<b>DA NO</b>	DA 113/2020
<b>ADDRESS</b>	4-18 Northwood Road & 274-274A Longueville Road, Lane Cove
<b>PROPOSAL</b>	Construction of a mixed-use development including a 143-bed residential aged care facility and commercial premises including a medical centre premises, and basement parking

**RE: UNSATISFACTORY DEVELOPMENT PROPOSAL**

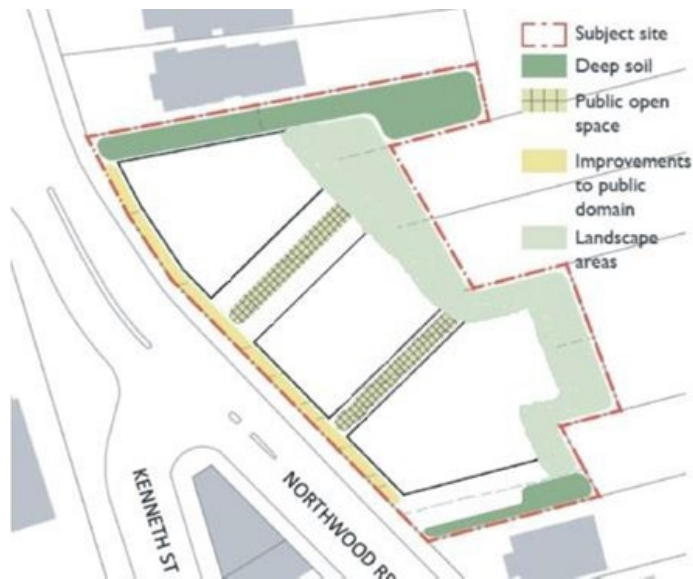
- Inconsistency with the desired future character for the site as expressed in the site-specific built-form controls for the site.
- The amended proposal has not addressed the requirement for adequate articulation to create visual interest in the facades.

1. Existing and proposed Council stormwater pipe system.

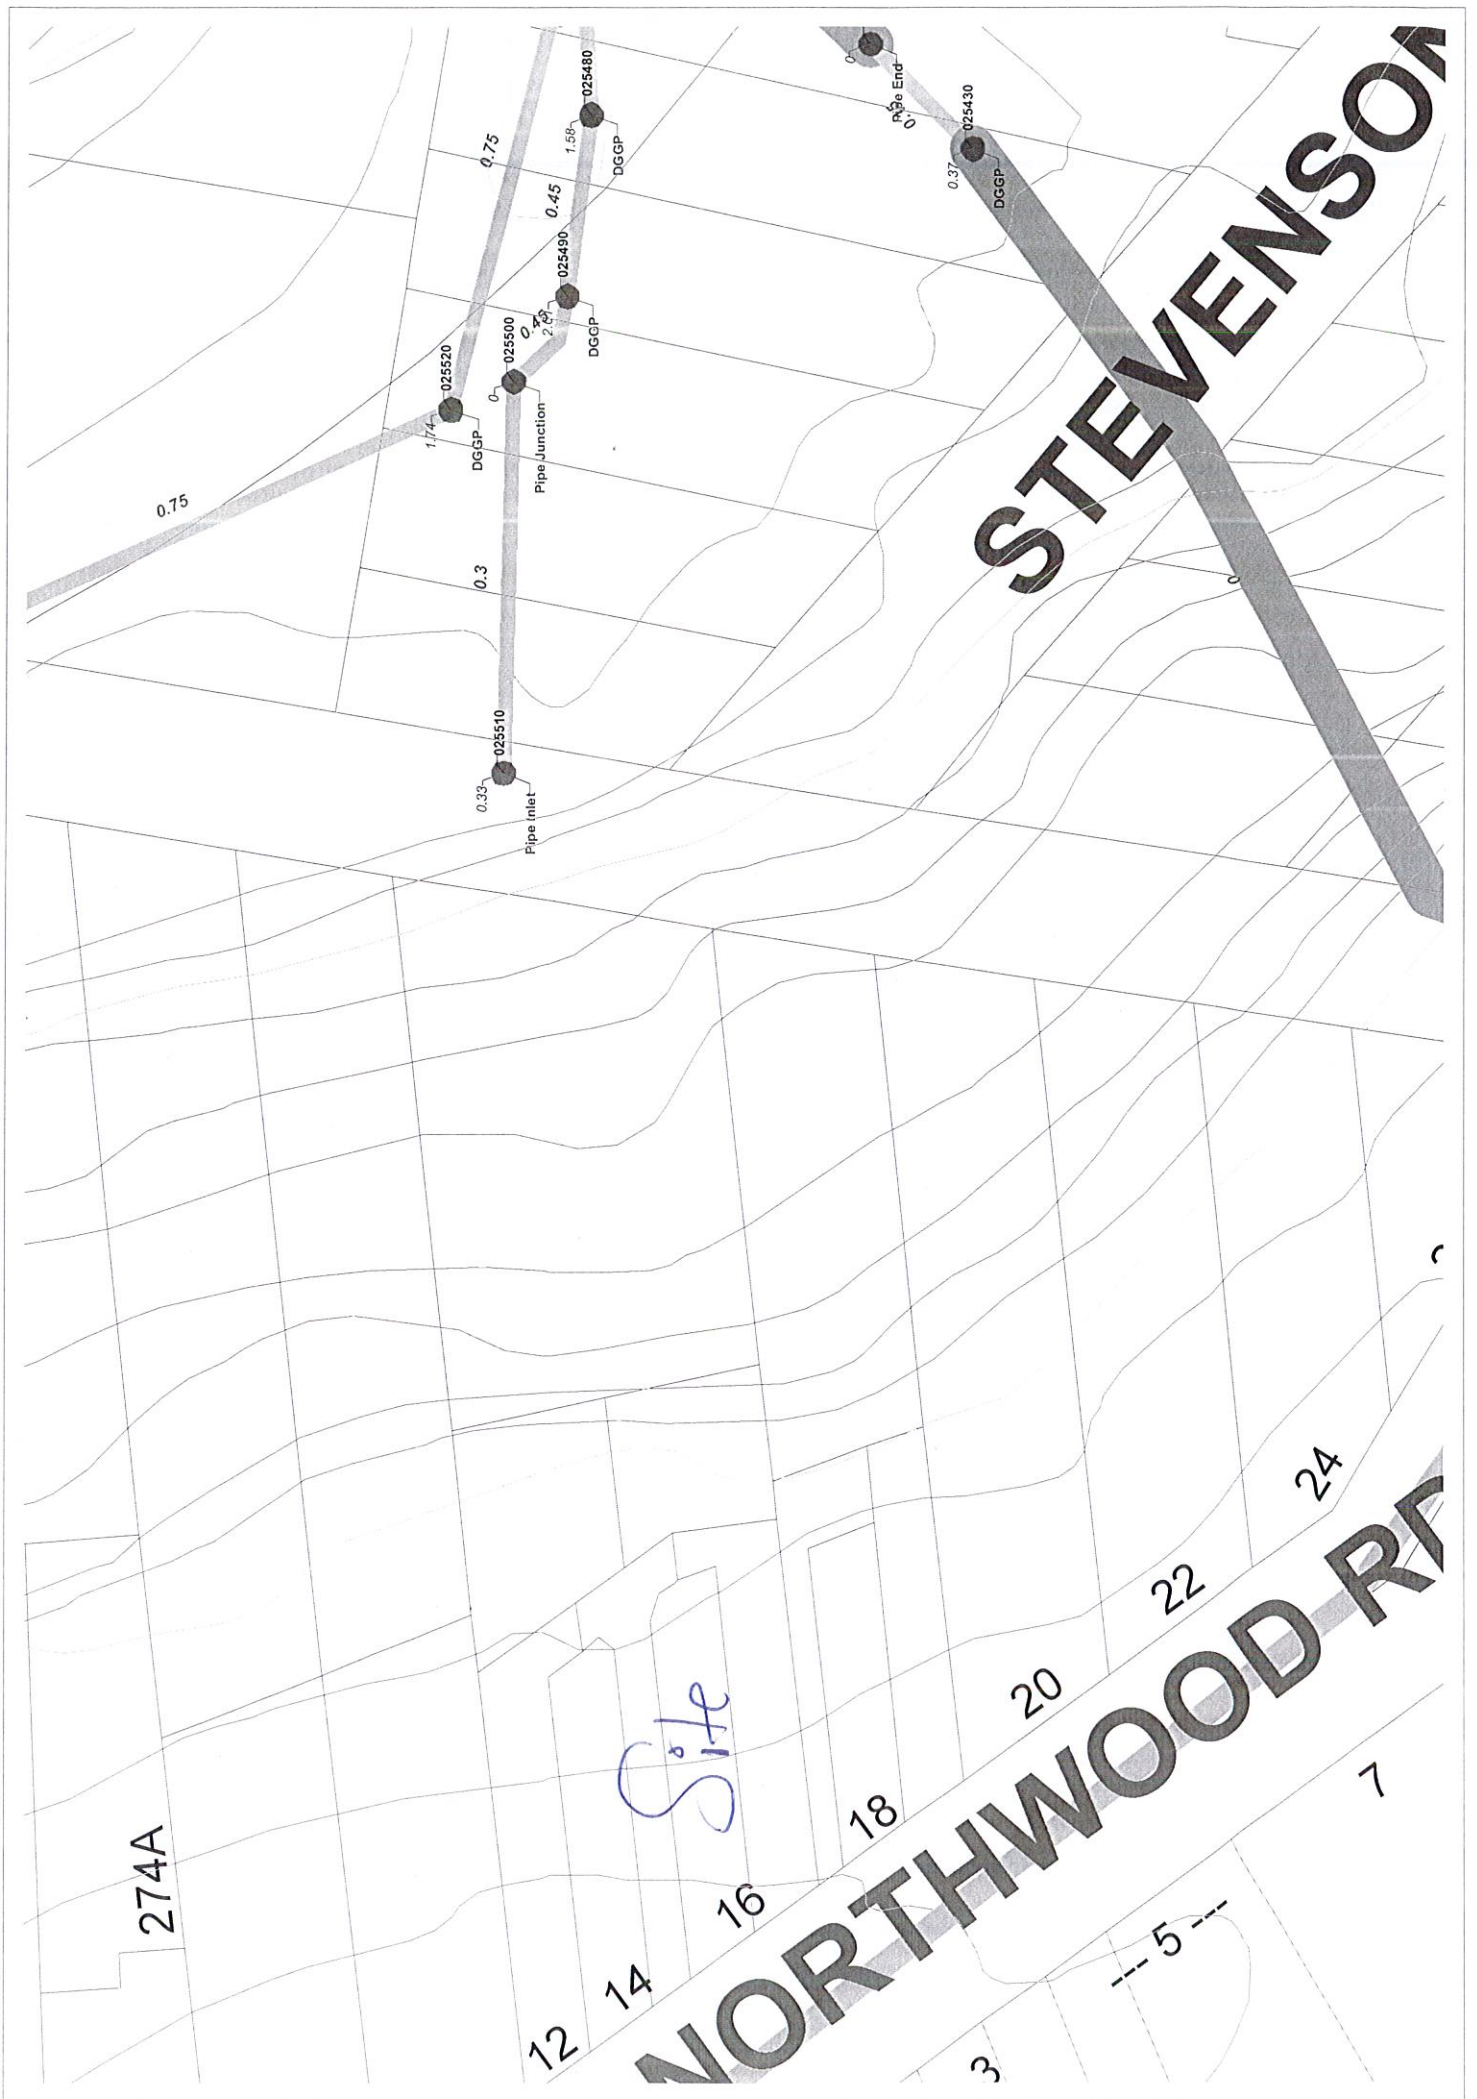
- Amended plans have been submitted to Council. Please refer **Annexure 1** for the existing Council pipe system at the rear of the site and approximate location of the new pipe system from the site to the Council pipe system at Golf course.

- Since the there is a proposal for a tennis court and basement car park as shown in attached document at the Golf course, the proposed pipe system shall be relocated away from this proposal. The pipe system through bush land must satisfy the requirements of Council’s Manager Open space.

- Annexure 10 shows a sketch for the approximate location for the new pipe system.
- A plan with longitudinal section of the proposed pipe system from the site to the existing Council pipe system at Golf Course with relevant calculations are required for further assessment and/or approval. This plan should show pipe sizes, invert levels and existing surface levels to confirm that the pipe system satisfies Council’s DCP. This new pipe network satisfies part O of the Council’s stormwater DCP.
